## **ARTICLE 14. ONE AND TWO FAMILY DWELLING CODE**

### **Rule 2.1. CABO One and Two Family Dwelling Code; Amendments**

**FIGURE R502.8**  
**CUTTING, NOTCHING AND DRILLING**

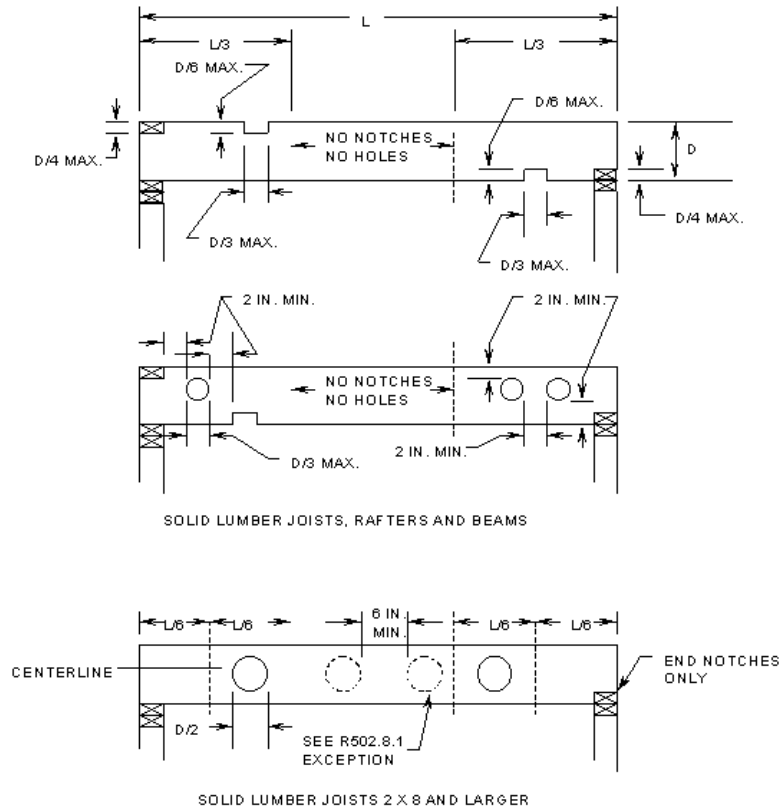
Sec. 88. Delete FIGURE R502.8 and substitute as follows: FIGURE R502.8:

FIGURE R602.6(2)  
NOTCHING AND BORED HOLE LIMITATIONS FOR INTERIOR NONBEARING WALLS

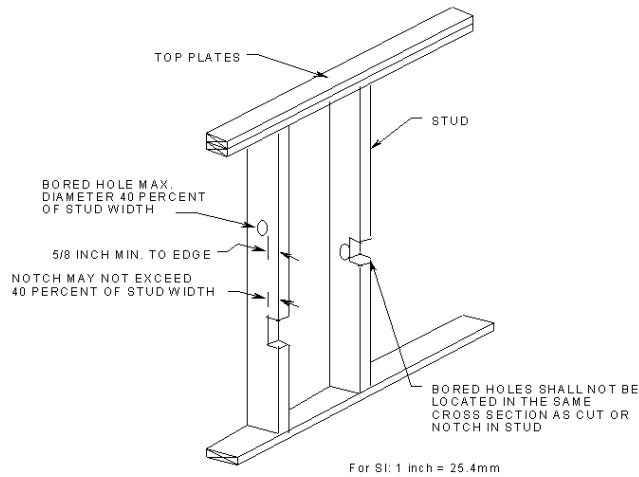
Sec. 95. Delete FIGURE R602.6(2) and insert FIGURE R602.6(2) to read as follows:

**FIGURE R602.10.5(2)**  
**GARAGE DOOR BRACED WALL PANEL FOR USE WITH CONTINUOUSLY SHEATHED WALLS**

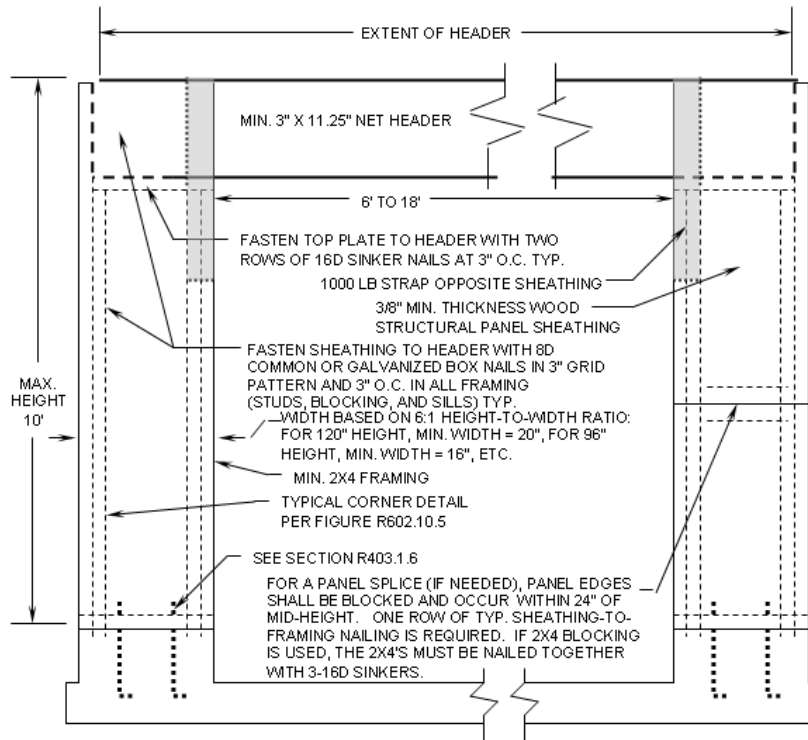
(4) Add FIGURE R602.10.5(2) to read as follows:

FIGURE R703.7.6(1)

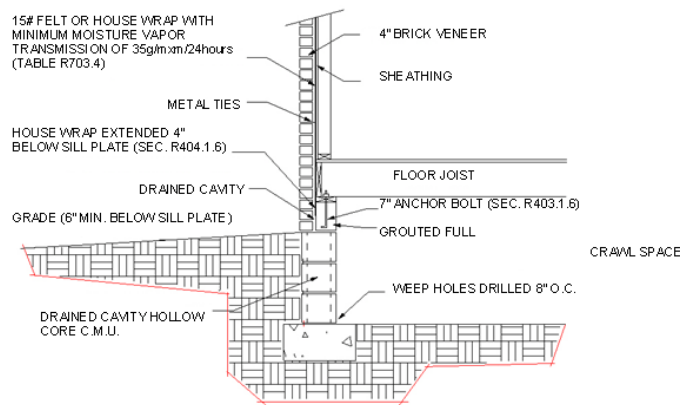
Sec. 121. Delete the title and text of SECTION R703.7.6 and substitute as follows: R703.7.6 Drained cavity. The 3/4 inch (19 mm) air cavity shall be drained to the exterior of the structure at intervals of not more than 33 inches (838 mm) on center. Each drain shall be not less than 3/16 inch (4.8 mm) in diameter, located immediately above the flashing. For dwellings with crawl spaces, the air cavity may be drained as shown in FIGURE R703.7.6(1). For dwellings with basements, the air cavity may be drained as shown in FIGURE R703.7.6(2).

FIGURE R1001.6  
Chimney Termination

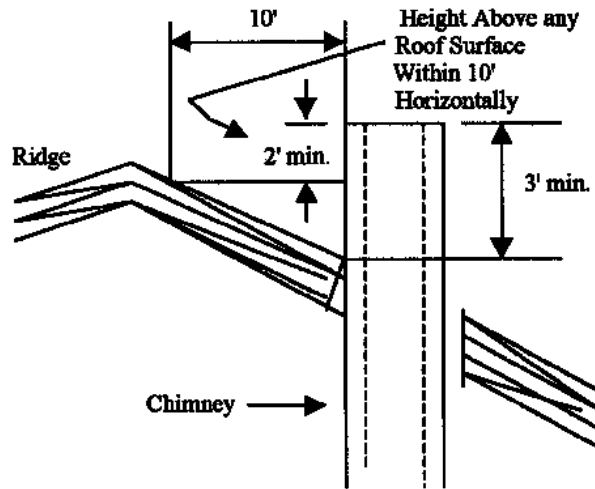
Sec. 135. Add FIGURE R1001.6 as follows:

**FIGURE E3801.4.1**

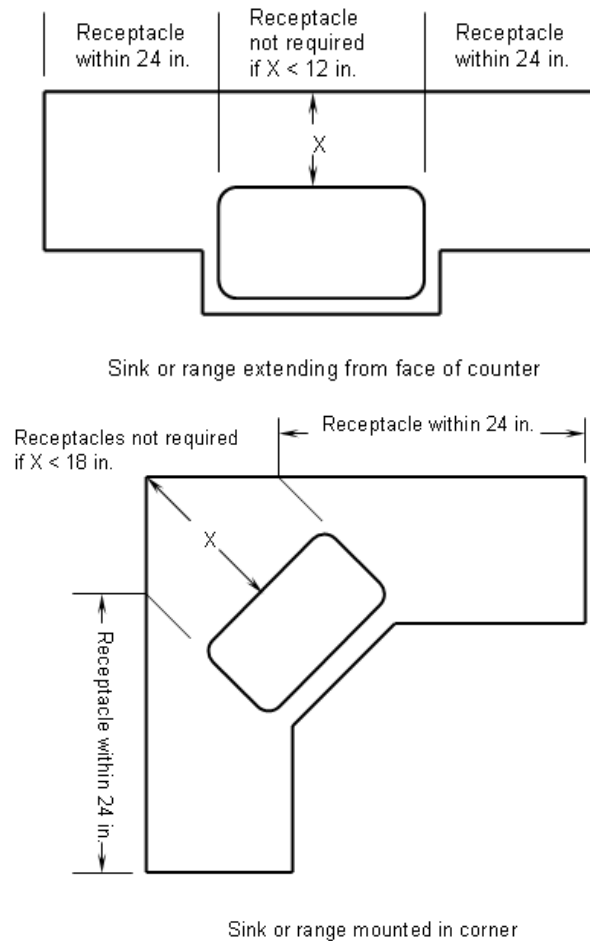
Sec. 229.5. (a) After SECTION E3801.4.1, add an exception to read as follows: Exception: Receptacle outlets shall not be required on a wall directly behind a range or sink in the installation described in FIGURE E3801.4.1.

(b) After SECTION E3801.4.1, add FIGURE E3801.4.1 as follows:
